West Farm Pit / M-2008-078 / TR-05 / Adequacy Review

Re: *West Farm Pit, Permit No. M-2008-078, Technical Revision No. 5 (TR-05), Adequacy Review No. 1 Response*

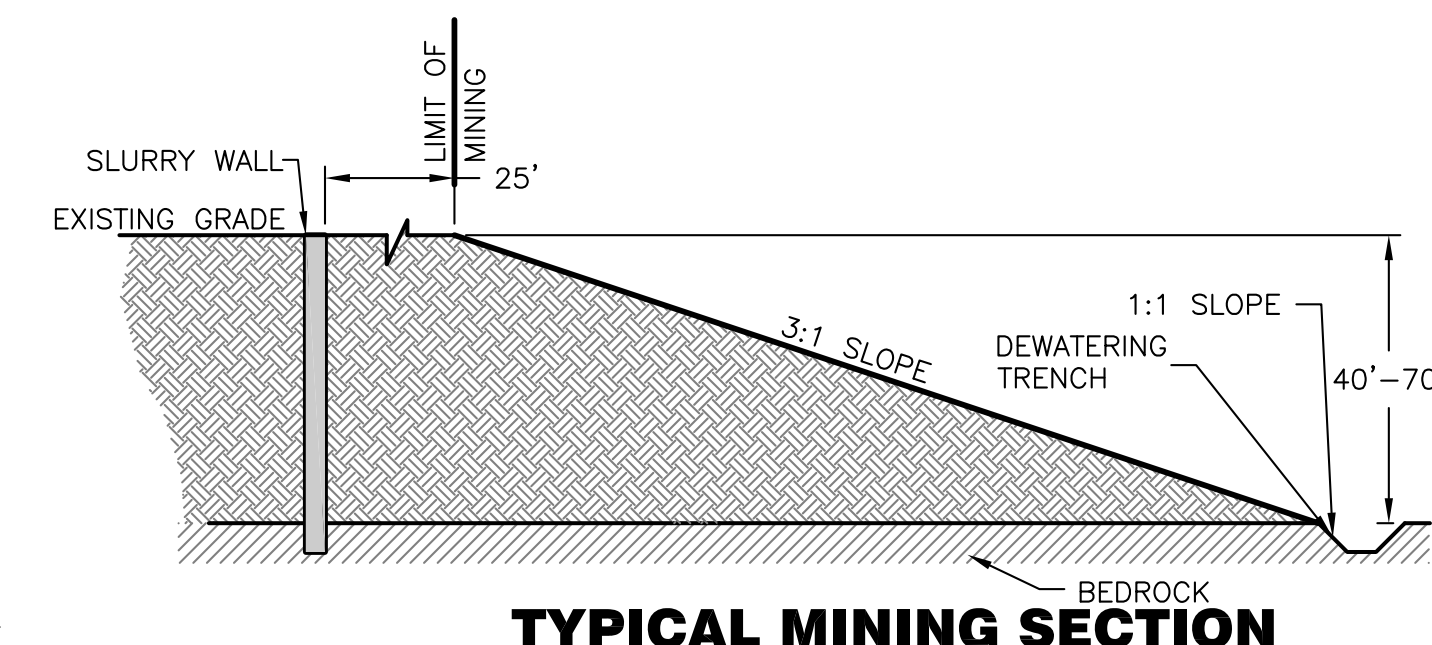
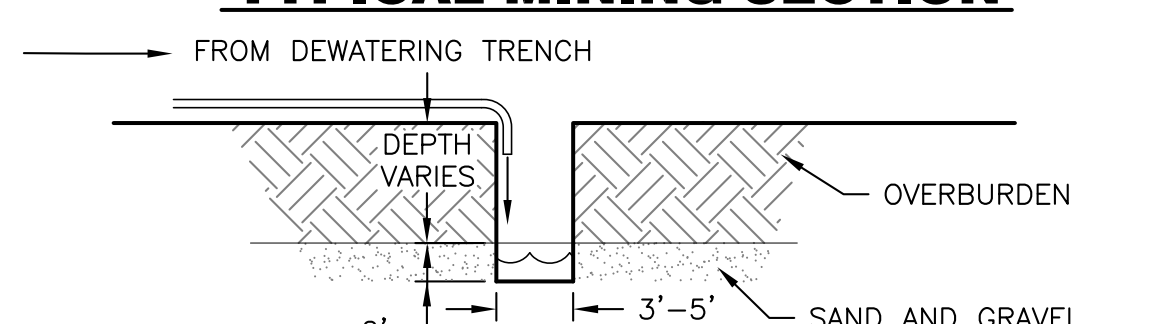
1) Please provide more details on the proposed conveyor system, including its approximate dimensions, the type of support pads/footings, and the number of support pads/footings required.

- 7) *Please provide a revised reclamation plan map including the proposed conveyor system reclamation.*

See the attached revised Exhibit C-1 Pre-Mining/Mining Plan Map showing the layout of the conveyor, culvert, and radial stackers.

The final reclamation plan for the pit does not change due to the addition of a conveyor system. A revised Exhibit L Reclamation Phasing Map is attached which shows the conveyor system.

West Farm Pit
CR HH.5 Culvert Crossing

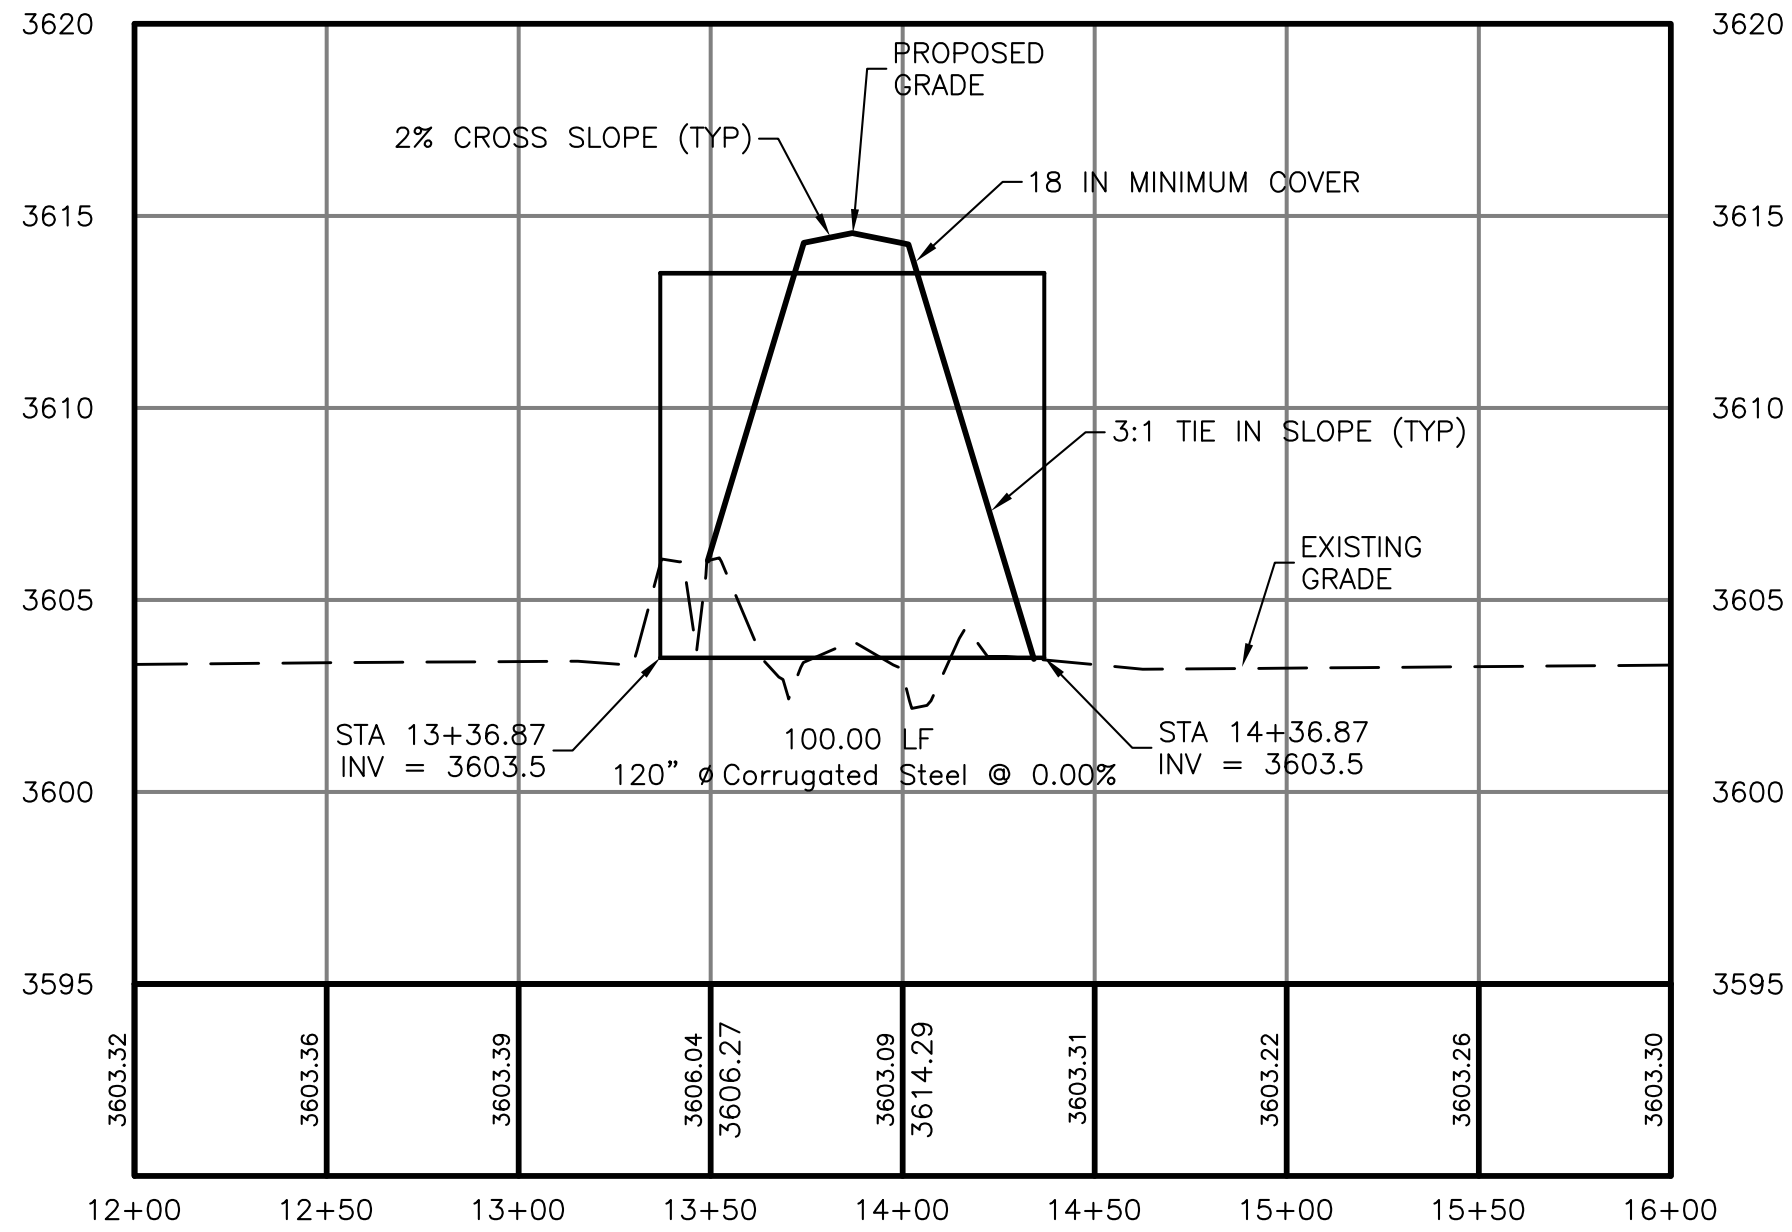
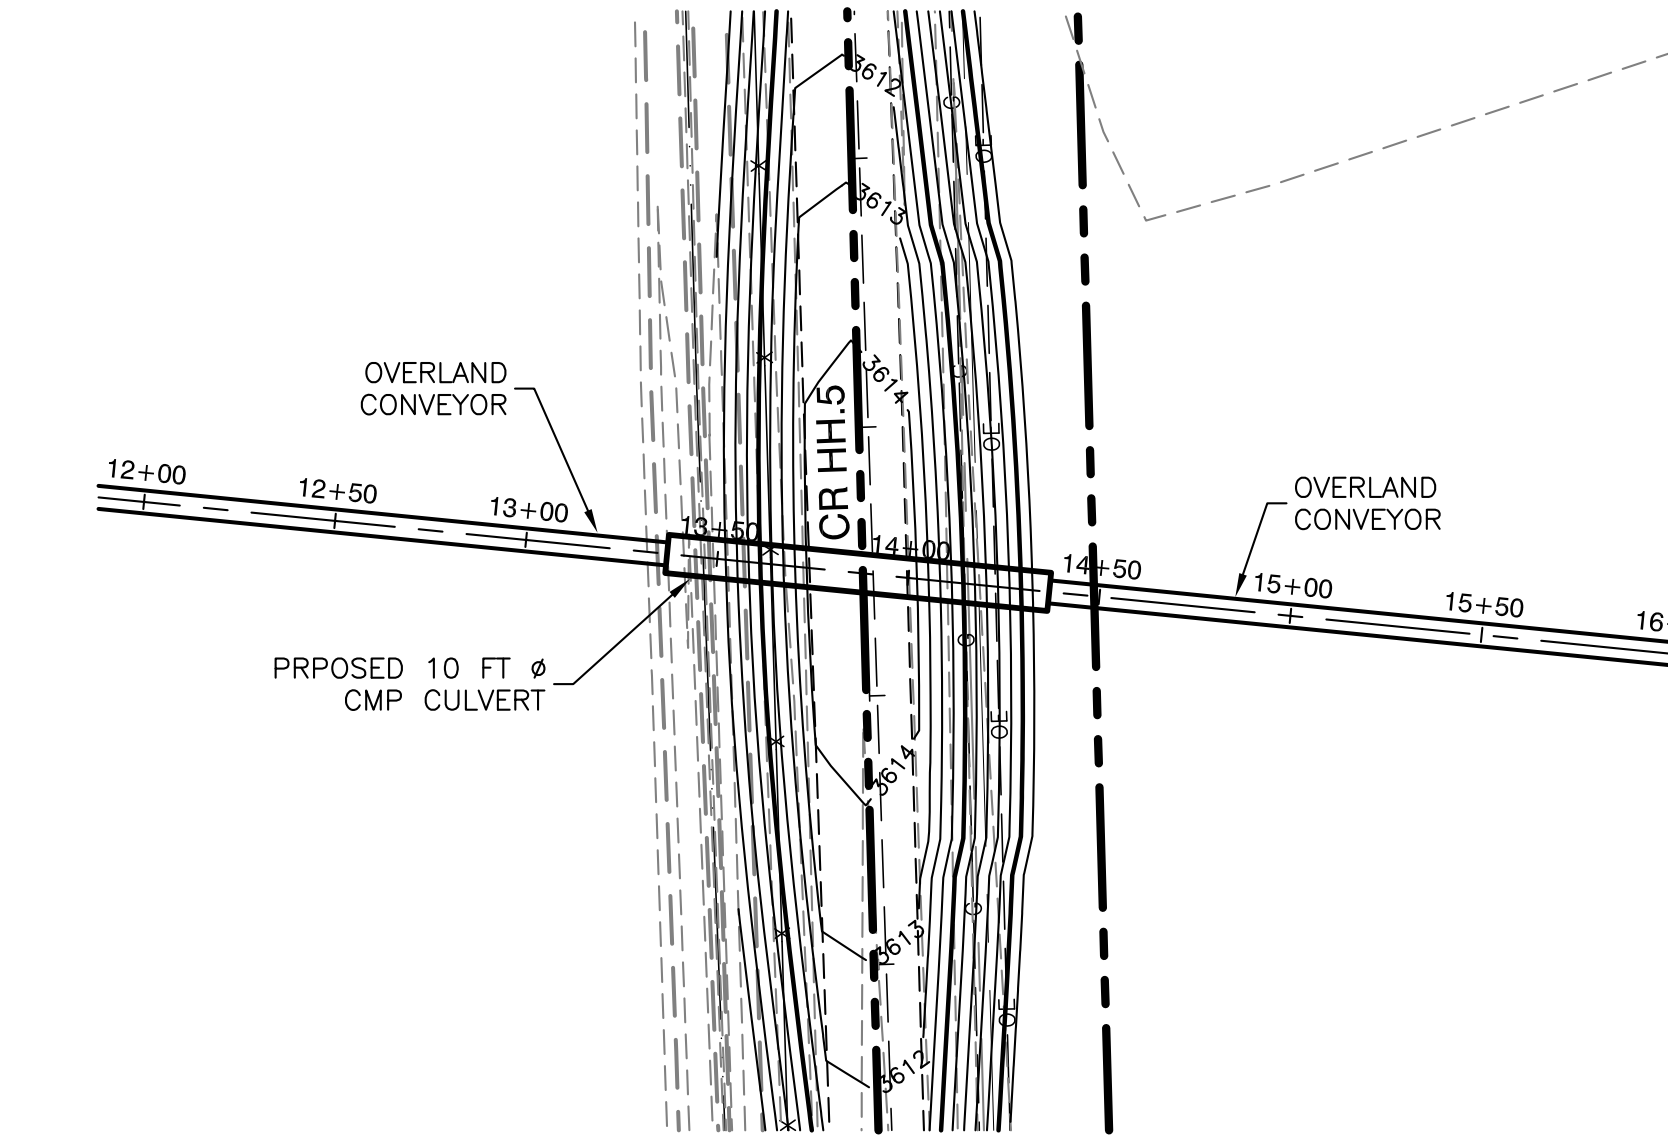
- 3) *Please provide more details on the portion of the proposed conveyor system to be installed beneath County Road HH.5, including the design drawing(s) for the culvert installation.*

The conveyor will run through a 10 ft diameter corrugated metal culvert across CR HH.5. This culvert will be placed at existing grade across CR HH.5. Pit run material will then be placed over the culvert and on top of CR HH.5 approaching the culvert to regrade CR HH.5 in this area, allowing CR HH.5 to pass over the culvert. See the attached CR HH.5 plan and profile and culvert crossing drawings.
